Electricity Network Innovation Competition Full Submission

Supplementary Answer Form

Project: Celsius

Project code	ENWEN 01	Question Number	01
Question date	25/8/2015	Answer date	27/8/2015
Submission section question relates to	Section 2		
Topic	Aims & Objectives

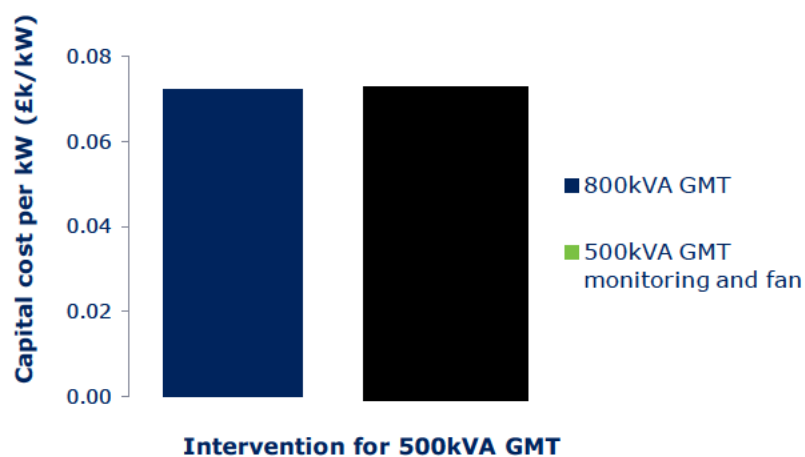
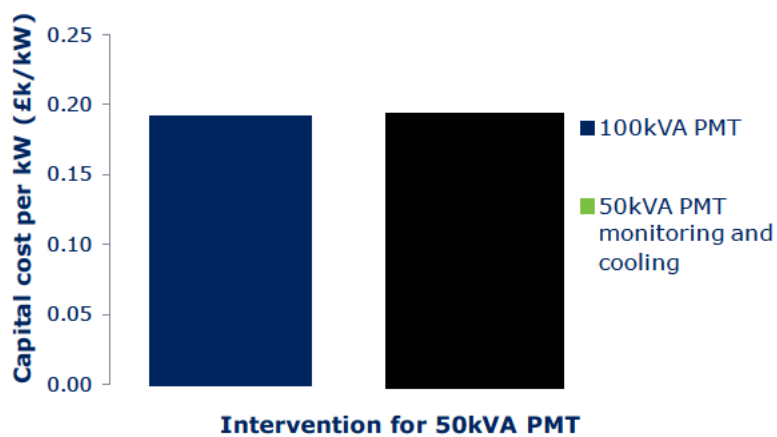
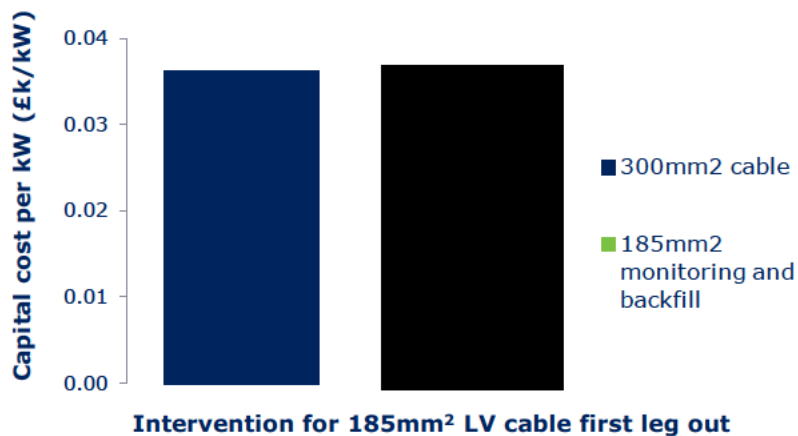
Question	On page 11 it says that load diversity is lowest at that secondary distribution level. Is there good evidence that this is true across all DNOs?		
Notes on question

Answer	As a distribution substation is a single demand point, it faces a defined demand profile, the result of diversity below it. In this introductory comment, low load diversity at the secondary distribution transformer was meant to express that the combined peak effect of customer load on the secondary networks can be the result of customers behaving in similar, non-diverse ways, as there is less potential for averaging out amongst customers, relative to HV and EHV assets serving a larger number of customers. This is common to all DNOs. In general, as we meant it, load diversity can be lowest at secondary substation level. Customer load connections at LV are often of a similar nature eg residential, and similar socio-economic groups, thus customer load tends to be clustered temporally. The connection of low carbon technology will exacerbate this further, as there may be little difference (diversity) in the load profiles of a group of heat pumps in a geographical cluster and operating at a similar time of day. At higher voltage levels, different types of load profiles, eg residential, commercial and industrial, different socio-economic groups, combine to increase diversity and loading is comparatively reduced. This may not hold true in specific instances due to the connection of large commercial or industrial customers at 11kV or 33kV reducing load diversity. However, this is the exception rather than the norm. We appreciate that using low/ high 'load diversity' to express whether

customers are acting similarly (non-diversely) or differently (diversely) may have been confusing. Load diversity is sometimes expressed in different ways eg as the sum of the peak loads for individual customers (or assets) relative to either the combined peak load or to the average load. In this sense we may think of limited diversity in customer behaviour at LV as having a high effect on average load relative to possible peak load, expressed as an after-diversity value.
Attachments
